Ltr	Date	By	REVISION DESCRIPTION
			University of Toronto, Quantum Optics Group
			Design: A. Stummer
			Date: 2017 July
			Edited: 2017-08-03 10:54 AM
			File: Loch Box
			Sheet: 1 of 3
			REV: A

Loch Box
A. Steinberg Labs

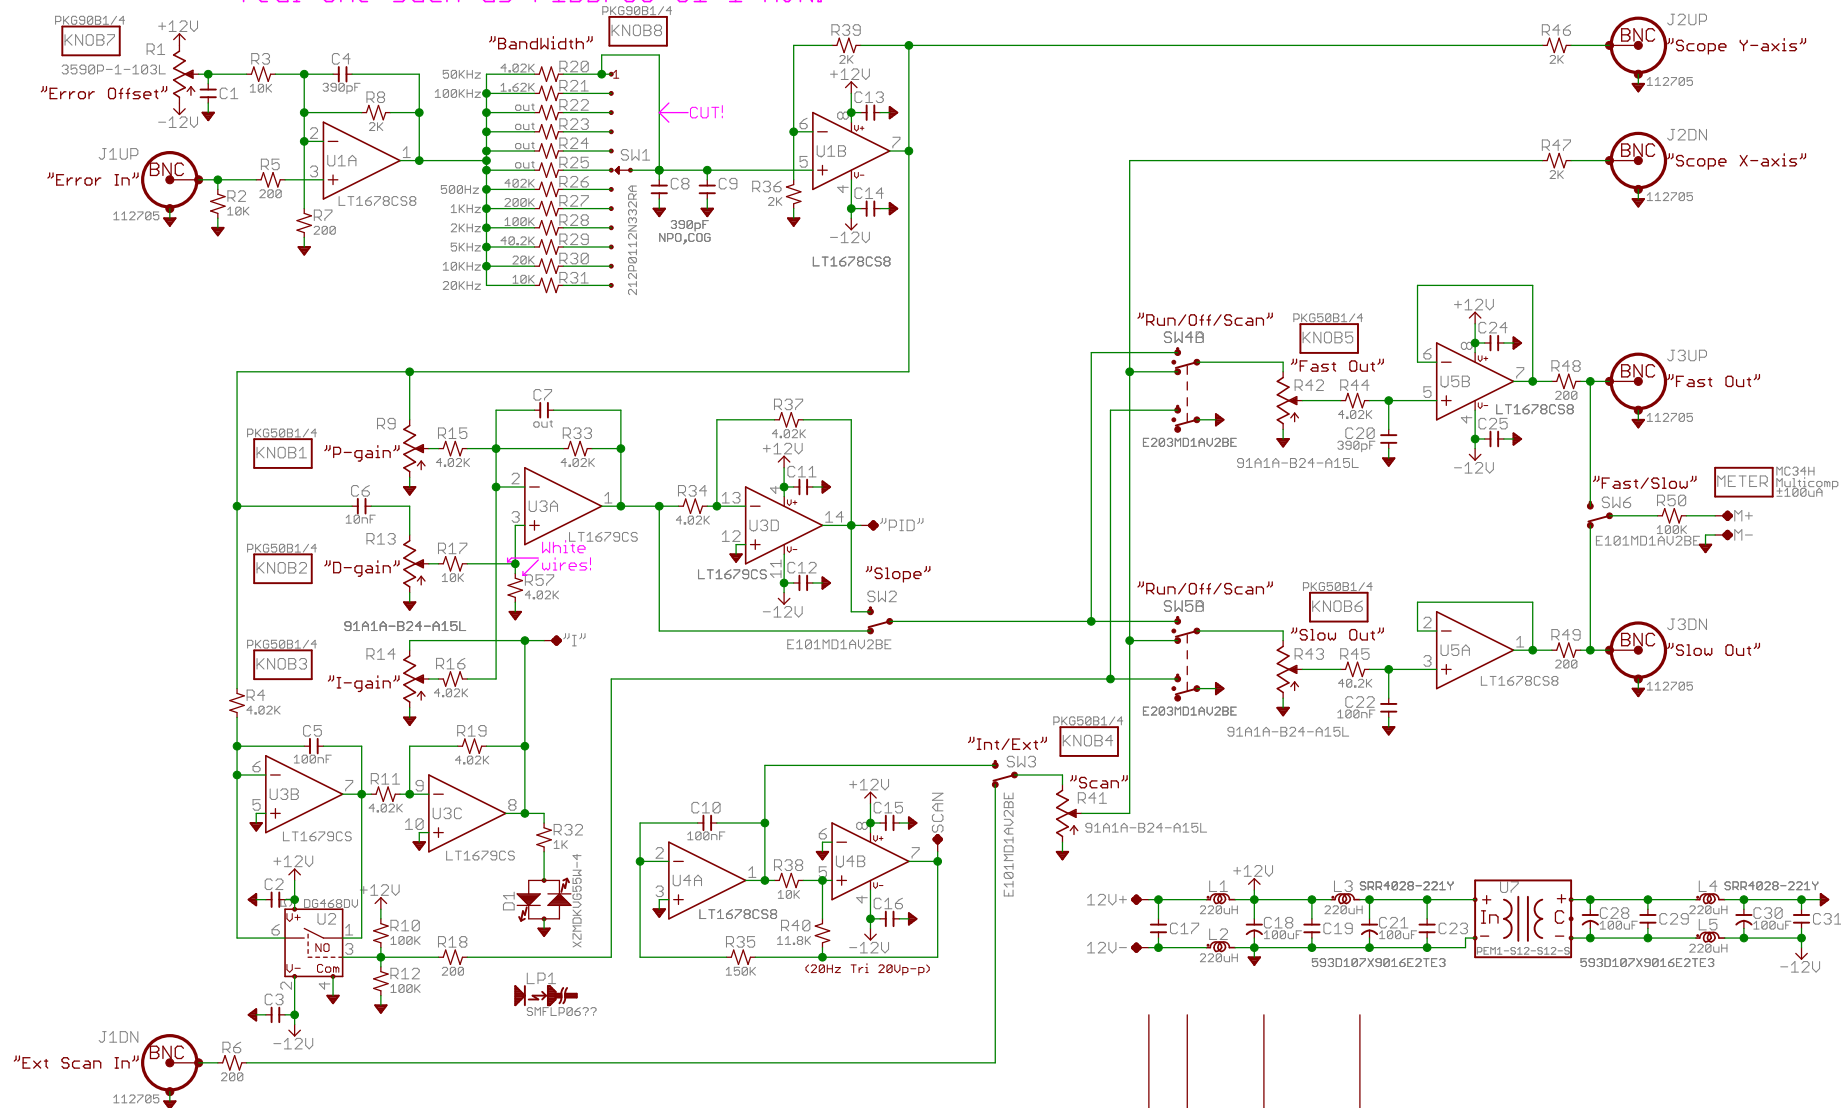
Rotary switch is crap. Replace with
real one such as 71BDF36-01-1-AJN.
